AMENDMENT TO THE REGIONAL WATER QUALITY MANAGEMENT PLAN

VILLAGE OF WALWORTH

AS ADOPTED BY THE
SOUTHEASTERN WISCONSIN REGIONAL PLANNING COMMISSION

RESPONSE TO REQUEST BY THE FONTANA-WALWORTH WATER POLLUTION CONTROL COMMISSION TO AMEND THE FONTANA-WALWORTH SANITARY SEWER SERVICE AREA

PROPOSED AMENDMENT TO THE FONTANA-WALWORTH SANITARY SEWER SERVICE AREA

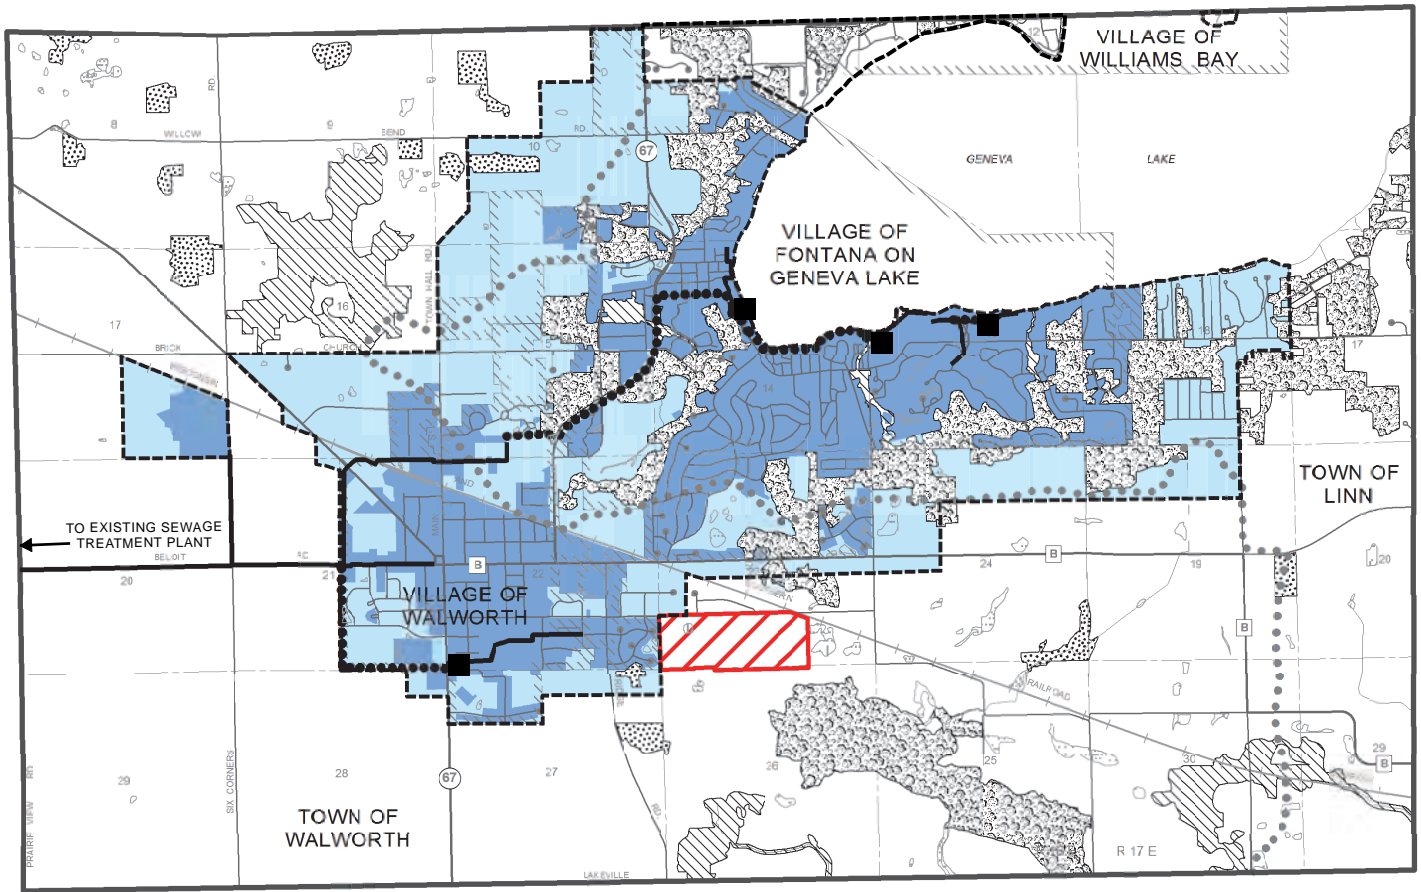
FIRST: That the regional water quality management plan for the Southeastern Wisconsin Region, being a part of the master plan for the physical development of the Region and comprised of SEWRPC Planning Report No. 30, Volumes One, Two, and Three, which was adopted by the Commission as a part of the master plan on the 12th day of July 1979, and which was subsequently amended to include the refined Fontana-Walworth sewer service areas, be and the same hereby is amended in the manner identified on Map 1 of the aforementioned SEWRPC staff memorandum.

As shown on Map 1, the area proposed to be added to the Fontana-Walworth sanitary sewer service area encompasses approximately 113 acres and is located on the south side of School Road within the southern half of U.S. Public Land Survey Section 23 and the northern half of U.S. Public Land Survey Section 26, Township 1 North, Range 16 East, Walworth County, Wisconsin.

Given all of the foregoing, it is recommended that the Southeastern Wisconsin Regional Planning Commission formally amend the Fontana-Walworth sanitary sewer service area as documented in SEWRPC Community Assistance Planning Report No. 219, as amended, in the manner shown on Map 1. It is also recommended that the Wisconsin Department of Natural Resources approve this sewer service area plan amendment and transmit the plan amendment to the U.S. Environmental Protection Agency for certification.

ENVIRONMENTALLY SIGNIFICANT LANDS AND PLANNED SANITARY SEWER SERVICE AREA FOR THE VILLAGES OF FONTANA AND WALWORTH AND ENVIRONS

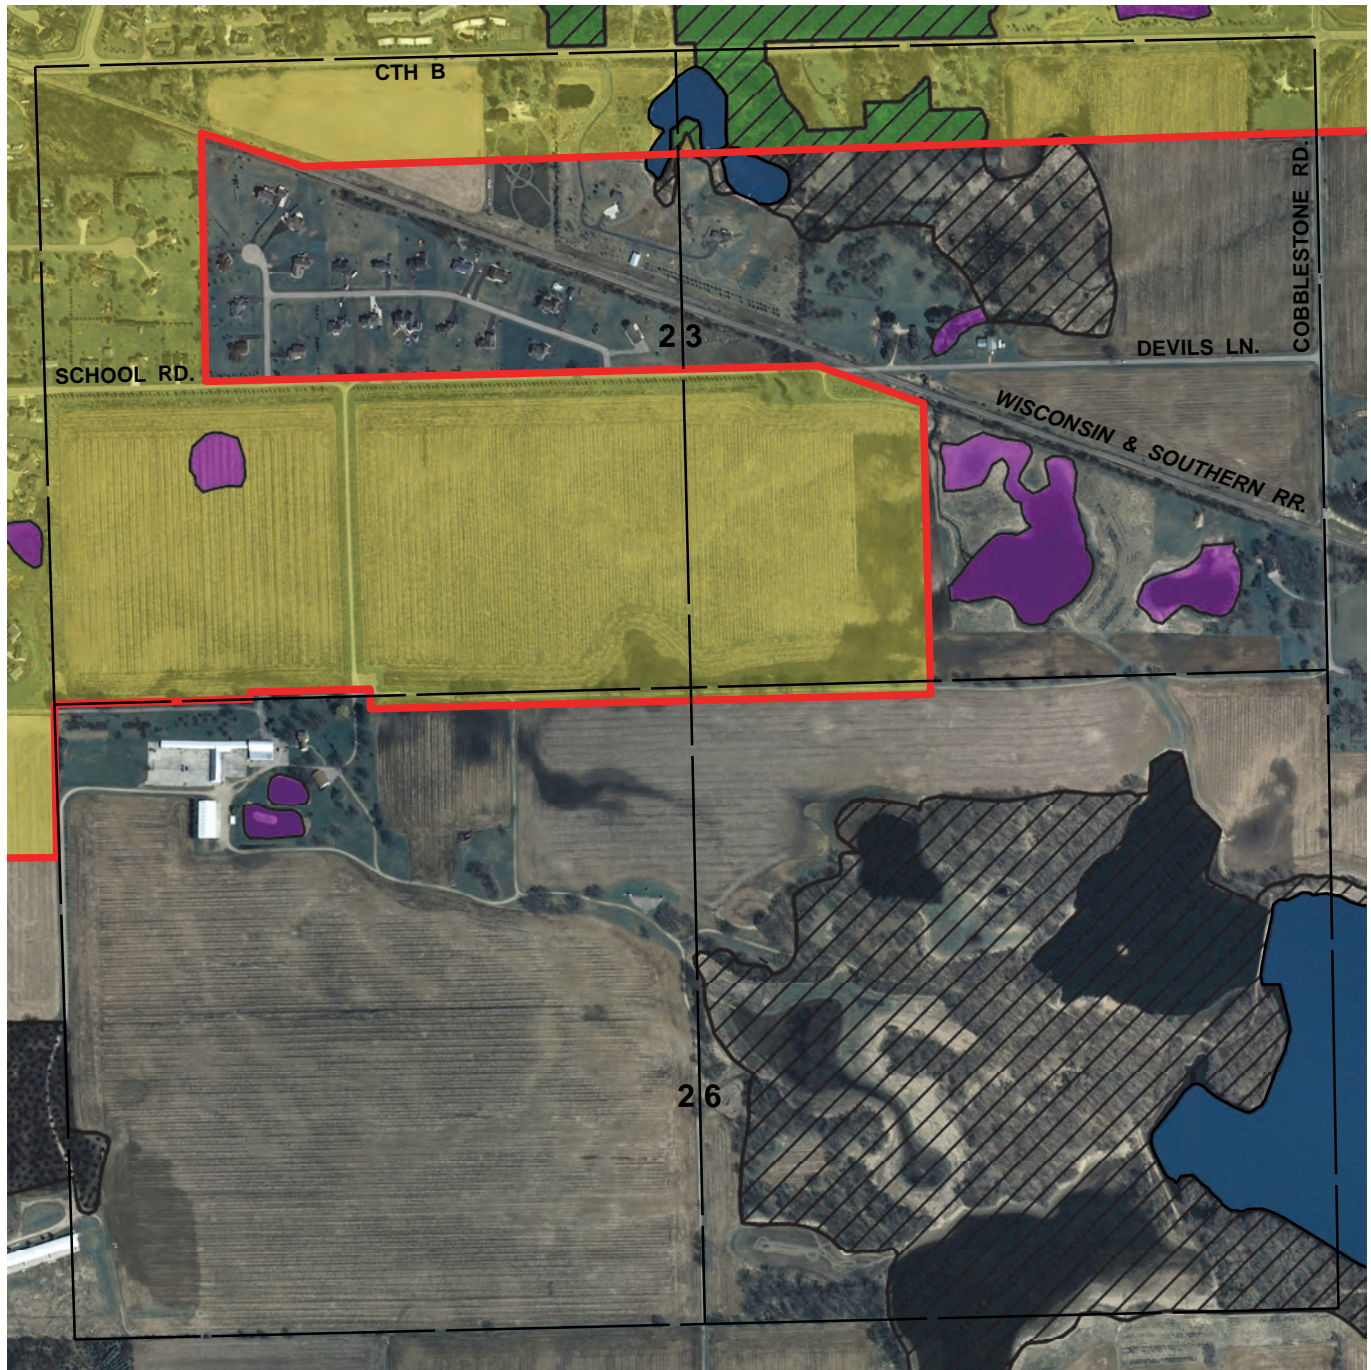
A more detailed delineation of the amended sewer service area is shown on the aerial photograph reproduced as Map 2.

NOTE: This map replaces portions of Map 7-7, page 25 and Map 7-11, page 29, of SEWRPC Community Assistance Planning Report No. 219, Sanitary Sewer Service Area for the Villages of Fontana and Walworth and Environs, June 1995.
